Subject: RE: Subject: DC/26/0640 – Cedar Cottage, Sandygate Lane, Lower Beeding, Horsham – Highway Safety and Access Concerns

I write regarding planning application DC/26/0640, submitted to Horsham District Council, for the demolition of the existing dwelling at Cedar Cottage, Sandygate Lane, Lower Beeding and the erection of 24 new dwellings, including the creation of a new access from Sandygate Lane with associated works.

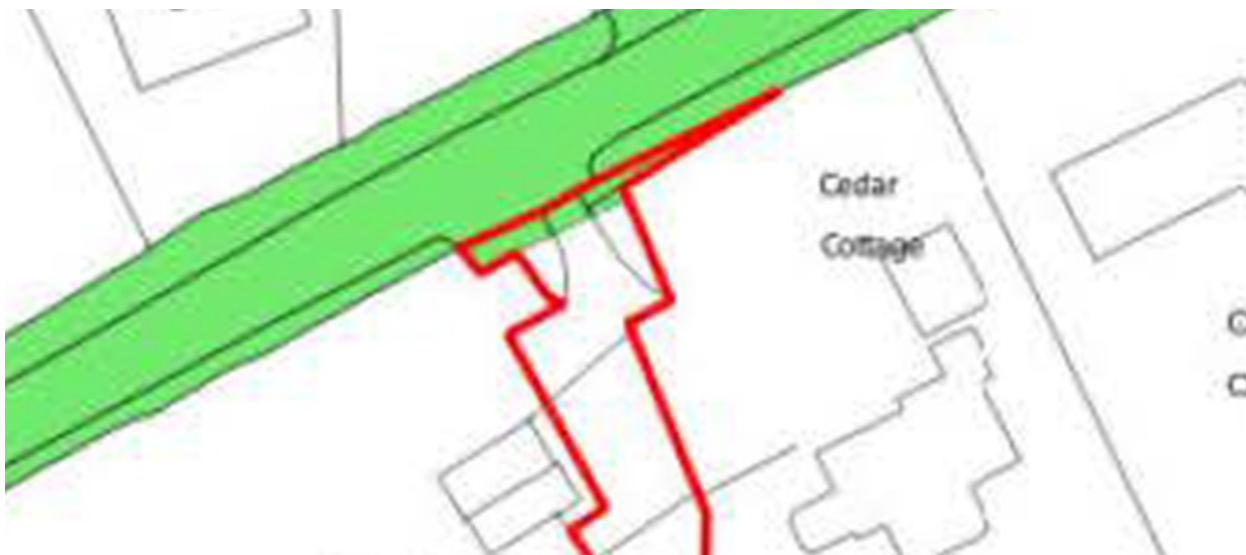
By way of example, the Proposed Site Access Arrangements and Associated Highways Works states that the “existing hedge overhanging the highway to be cut back”. Importantly, it also shows incorrectly the highway boundary referenced by the letter “H” as being some 1m within our property boundary. Interestingly, the proposed visibility splay follows the same line, as can be seen from the extract of the Proposed Site Access Arrangements and Associated Highways Works report below (page 9 of 9):
